RESERVE @ MITCHELL MILL
TOWN OF ROLESVILLE, WAKE COUNTY, NORTH CAROLINA
CONSTRUCTION PLANS
ZONING CONDITION

RESERVE @ MITCHELL MILL
TOWN OF ROLESVILLE, WAKE COUNTY, NORTH CAROLINA
CONSTRUCTION PLANS

RESERVE @ MITCHELL MILL
TOWN OF ROLESVILLE, WAKE COUNTY, NORTH CAROLINA
CONSTRUCTION PLANS
PARTIAL SITE PLAN I

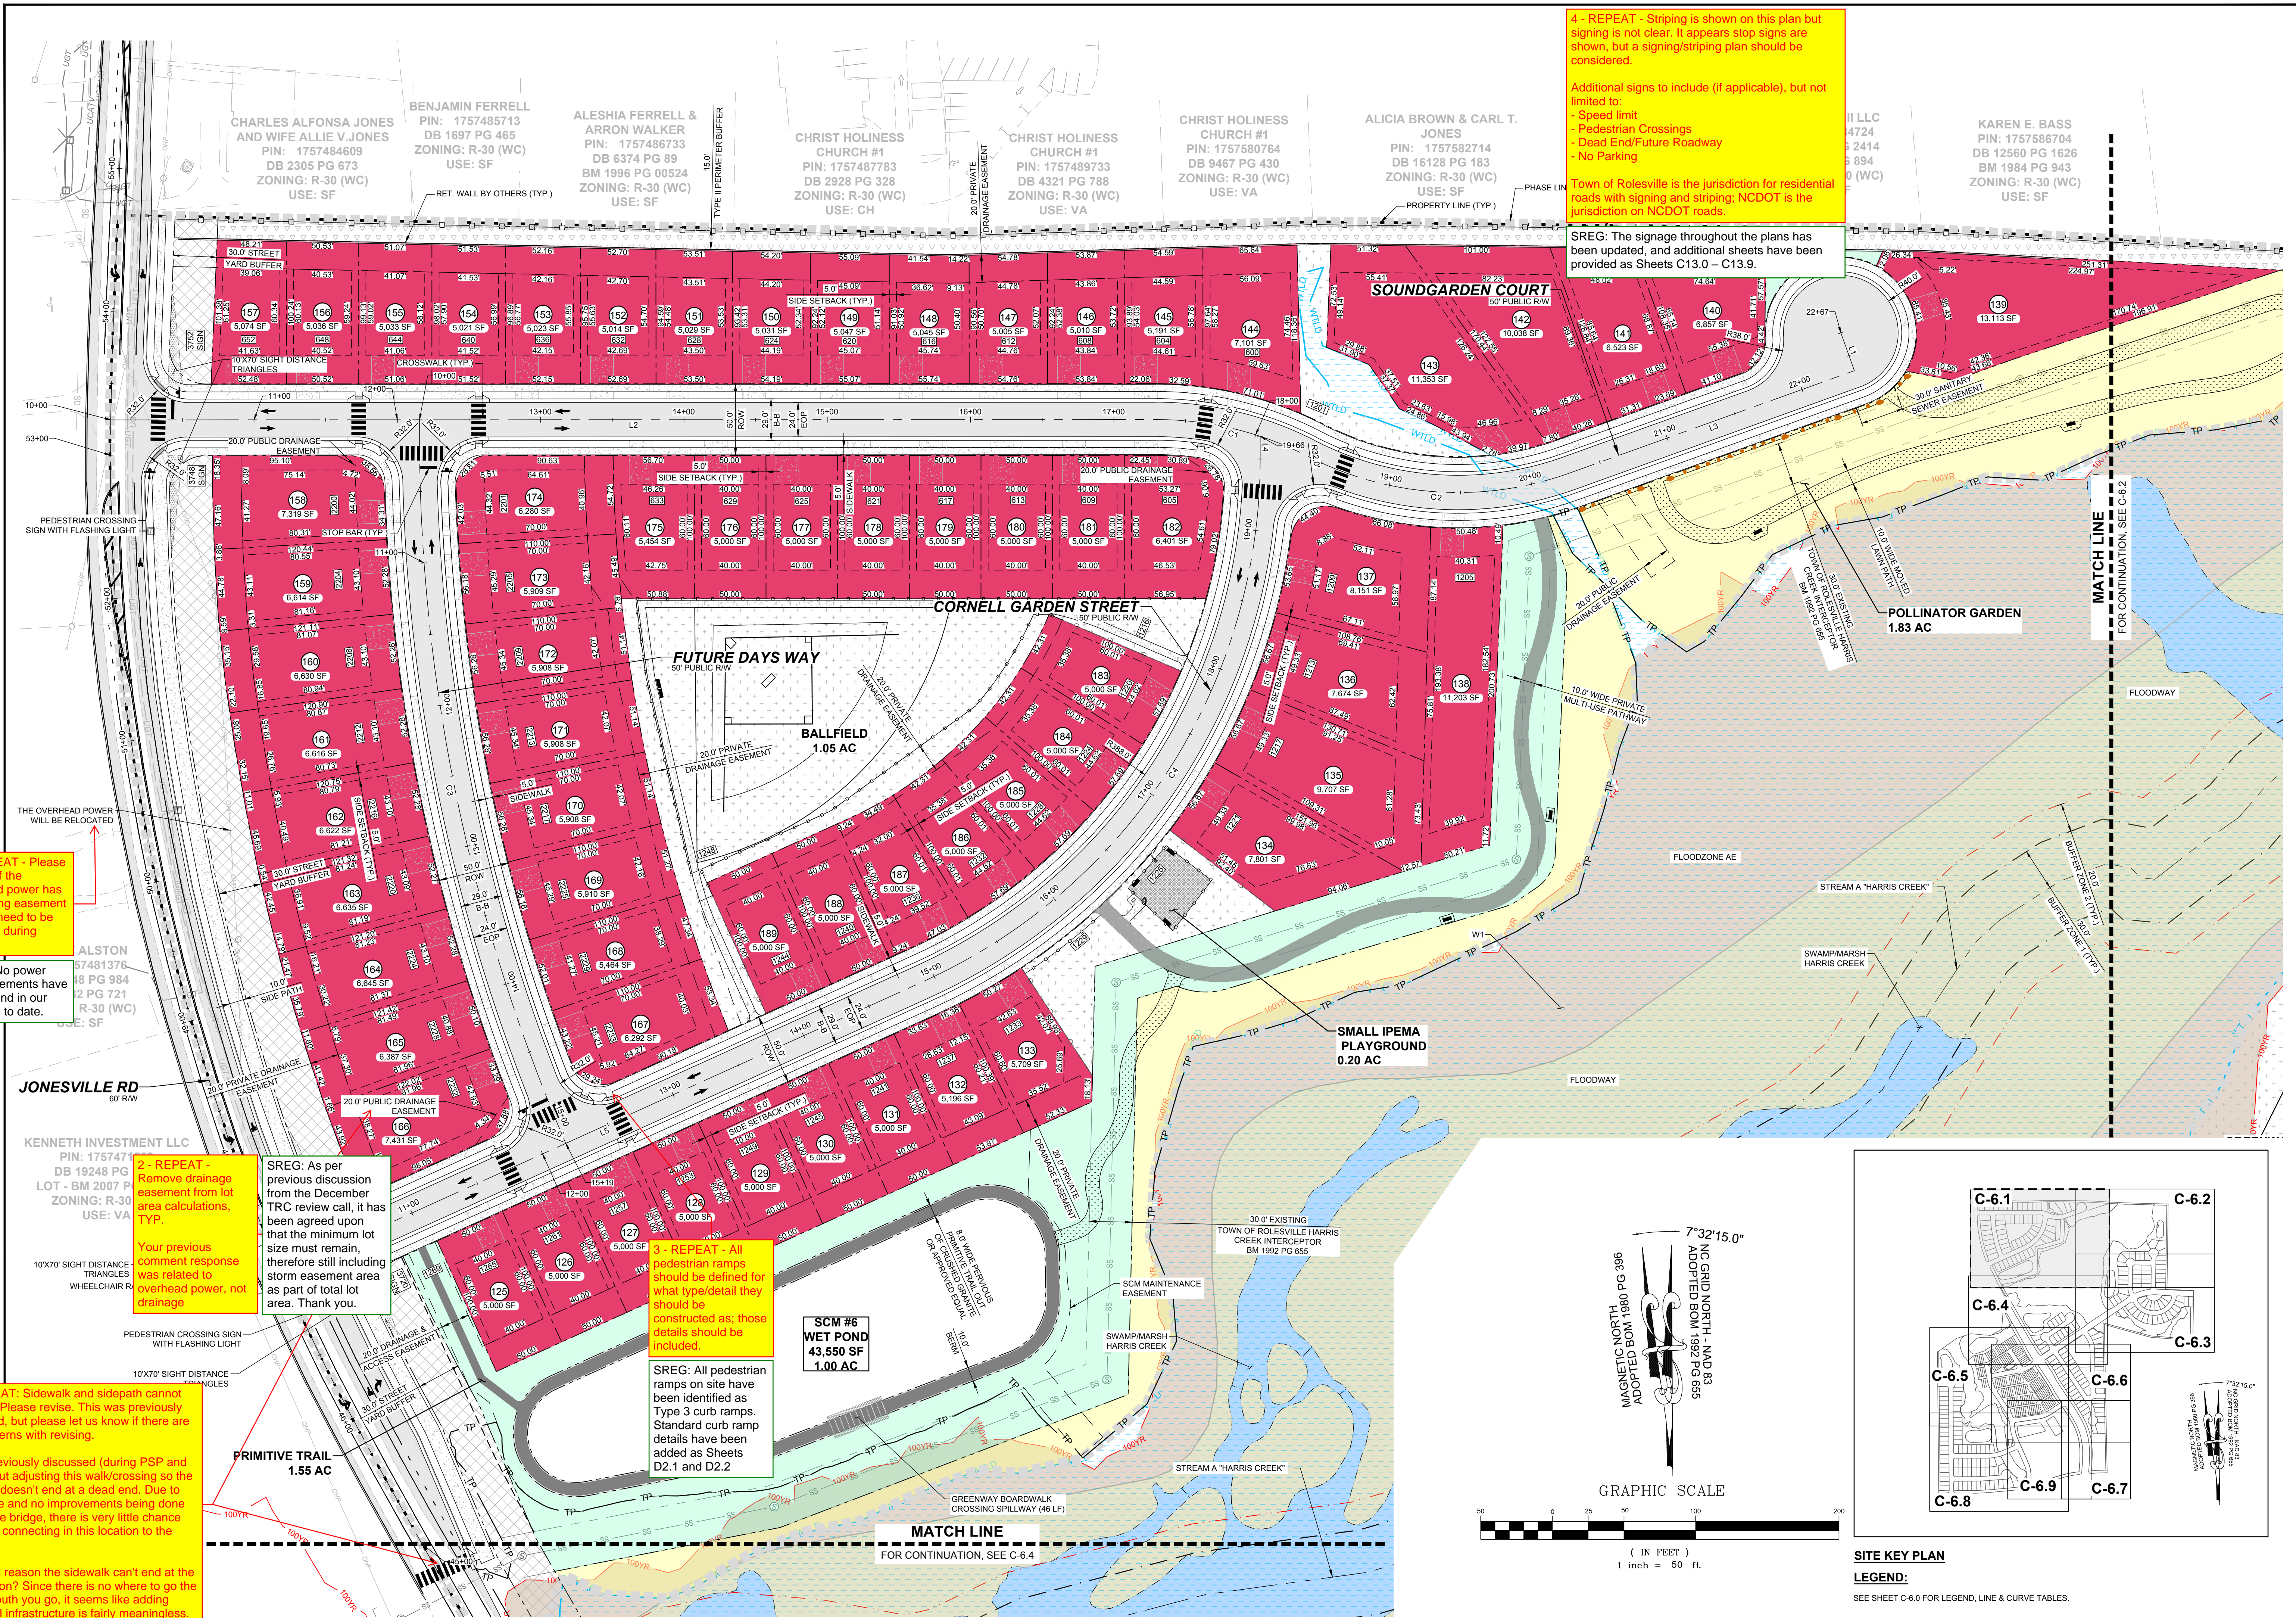
4 - REPEAT - Striping is shown on this plan but signing is not clear. It appears stop signs are shown, but a signing/striping plan should be considered.

2 - REPEAT - Remove drainage easement from lot area calculations, TYP.

Your previous comment response was related to overhead power, not drainage

5 - REPEAT: Sidewalk/sidepath cannot just end. Please revise. This was previously discussed, but please let us know if there are any concerns with revising.

It was previously discussed (during PSP and CID) about adjusting this walk/crossing so the sidewalk doesn't end at a dead end. Due to the bridge and no improvements being done across the bridge, there is very little chance for future connecting in this location to the south.

Is there a reason the sidewalk can't end at the intersection? Since there is no where to go the farther south you go, it seems like adding additional infrastructure is fairly meaningless.

3 - REPEAT - All pedestrian ramps should be defined for what type/detail they should be constructed as; those details should be included.

SREG: The signage throughout the plans has been updated, and additional sheets have been provided as Sheets C13.0 - C13.9.

SREG: This sidewalk/sidepath crossing has been revised, see Sheet C6.1

SREG: All pedestrian ramps on site have been identified as Type 3 curb ramps. Standard curb ramp details have been added as Sheets D2.1 and D2.2

RESERVE @ MITCHELL MILL
TOWN OF ROLESVILLE, WAKE COUNTY, NORTH CAROLINA
CONSTRUCTION PLANS
PARTIAL SITE PLAN IV

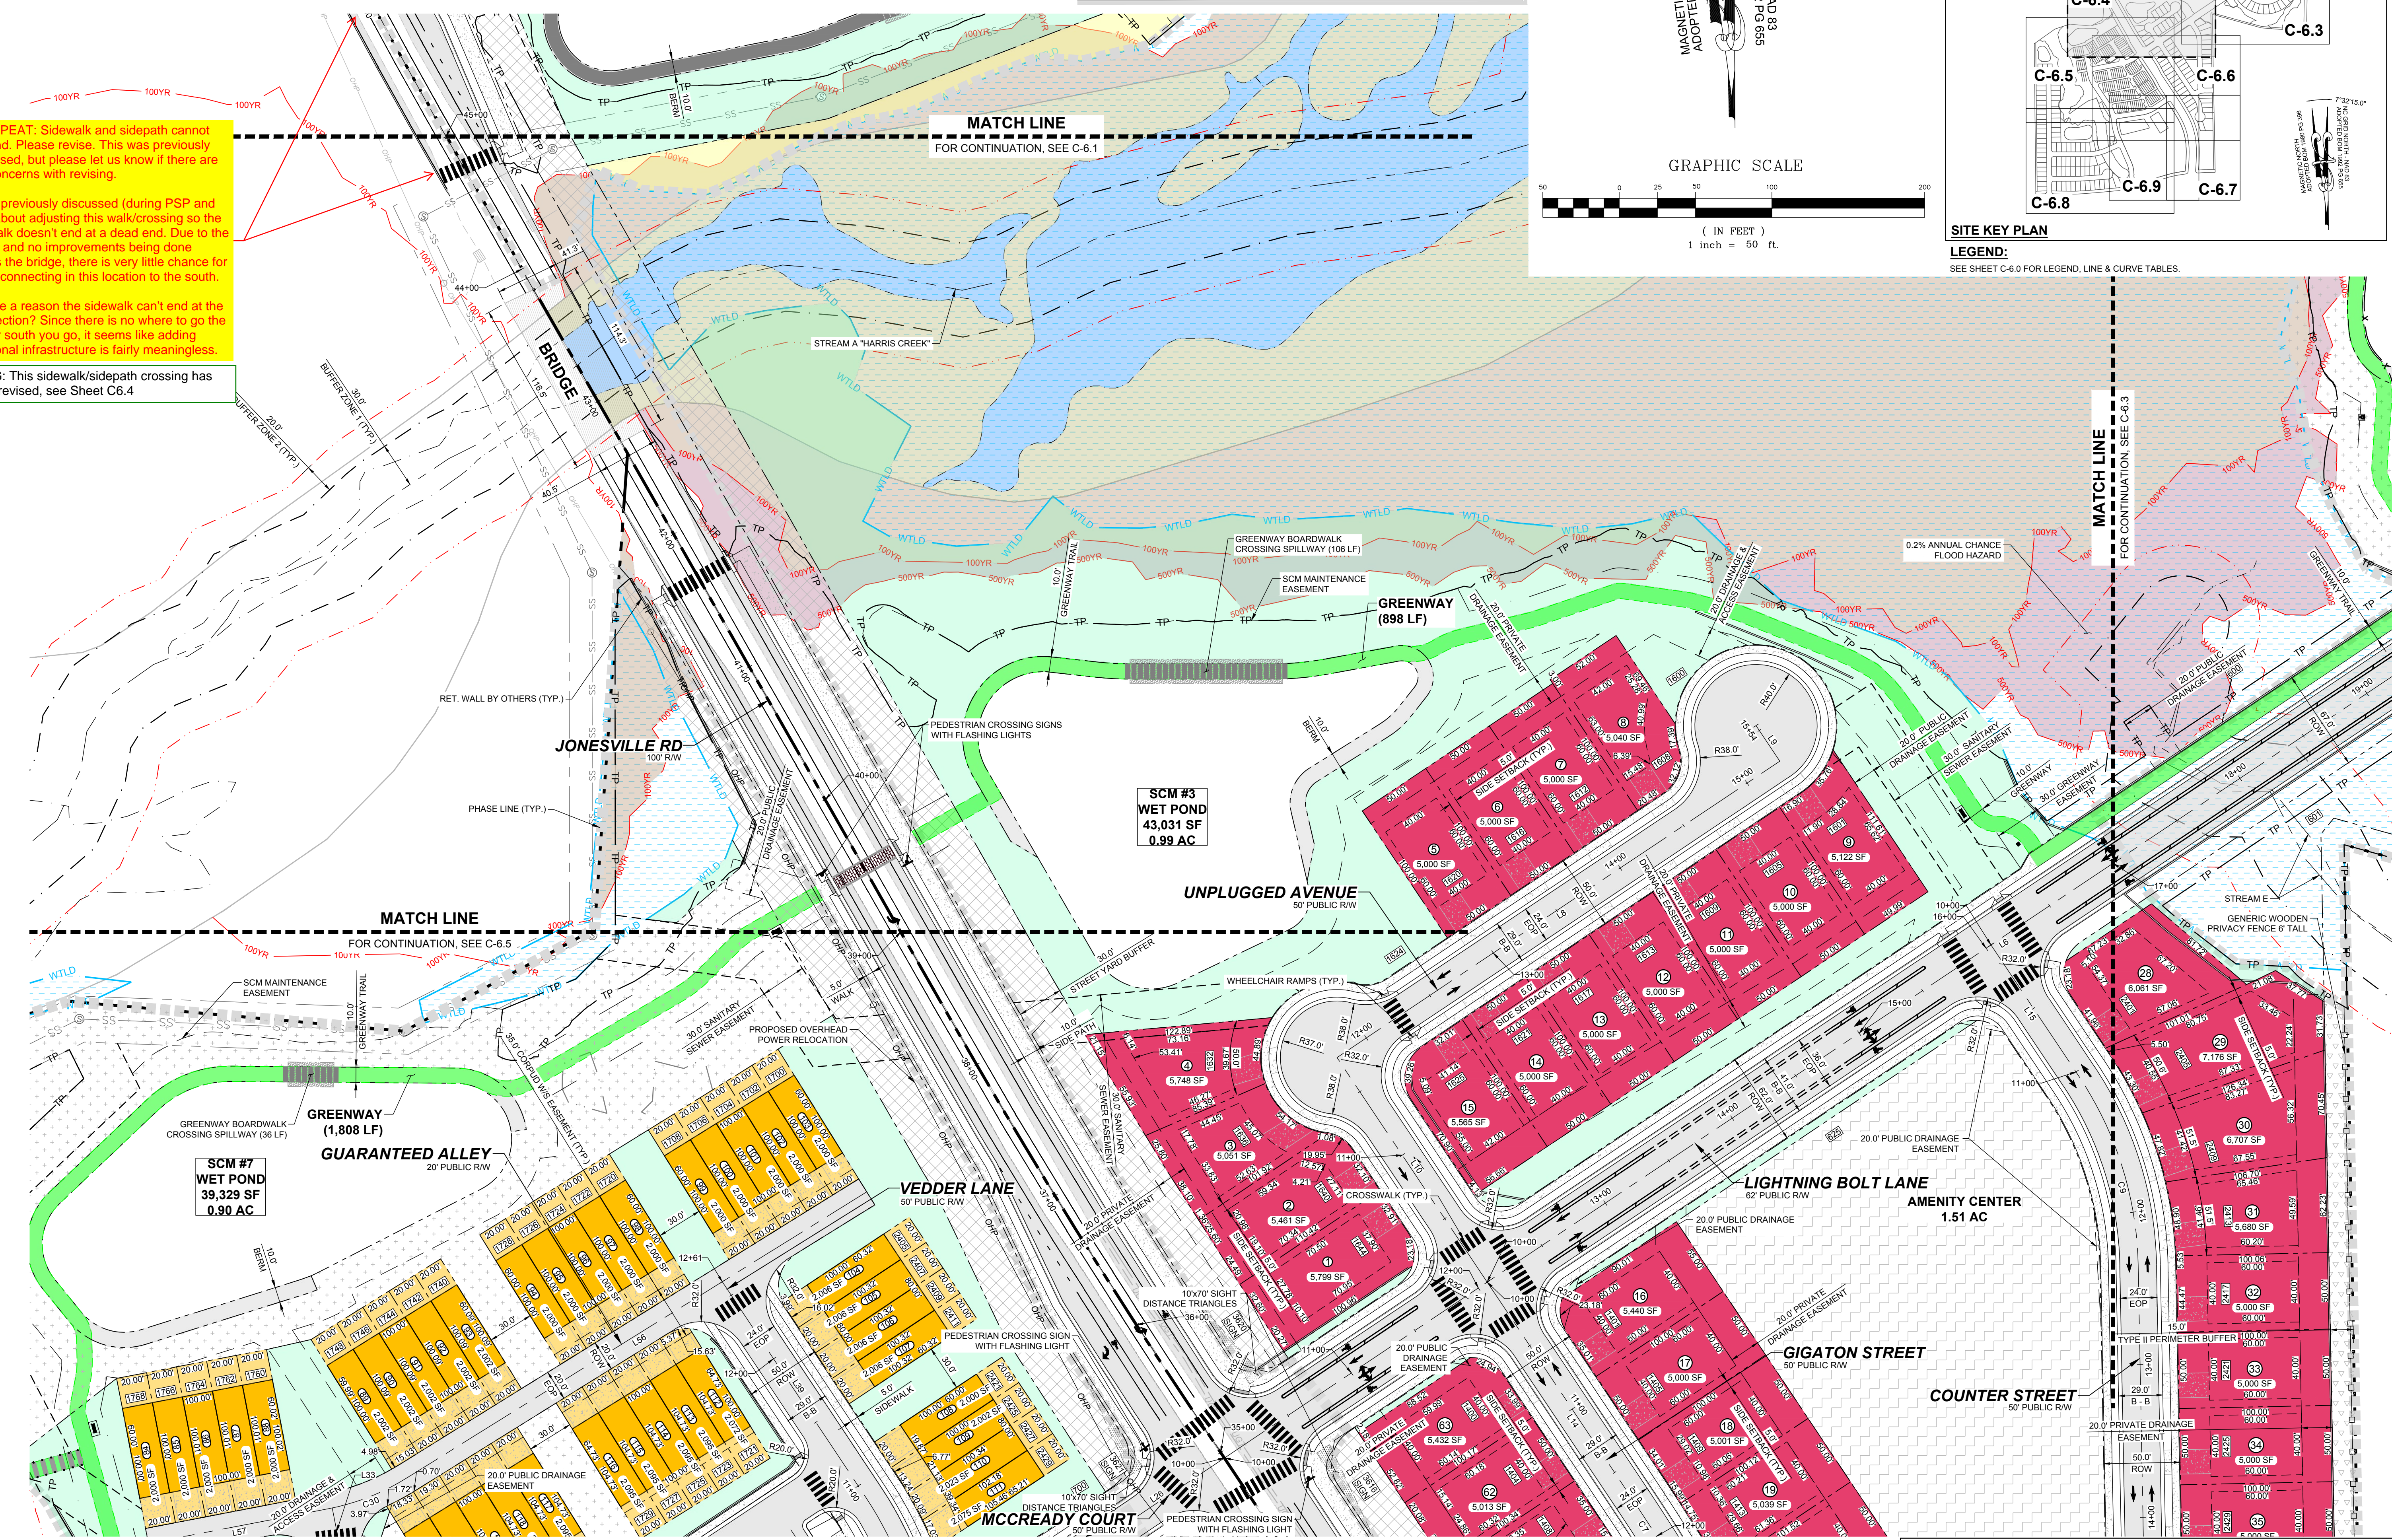
7 - REPEAT: Sidewalk and sidepath cannot just end. Please revise. This was previously discussed, but please let us know if there are any concerns with revising.

It was previously discussed (during PSP and CID) about adjusting this walk/crossing so the sidewalk doesn't end at a dead end. Due to the bridge and no improvements being done across the bridge, there is very little chance for future connecting in this location to the south.

Is there a reason the sidewalk can't end at the intersection? Since there is no where to go the farther south you go, it seems like adding additional infrastructure is fairly meaningless.

SREG: This sidewalk/sidepath crossing has been revised, see Sheet C6.4
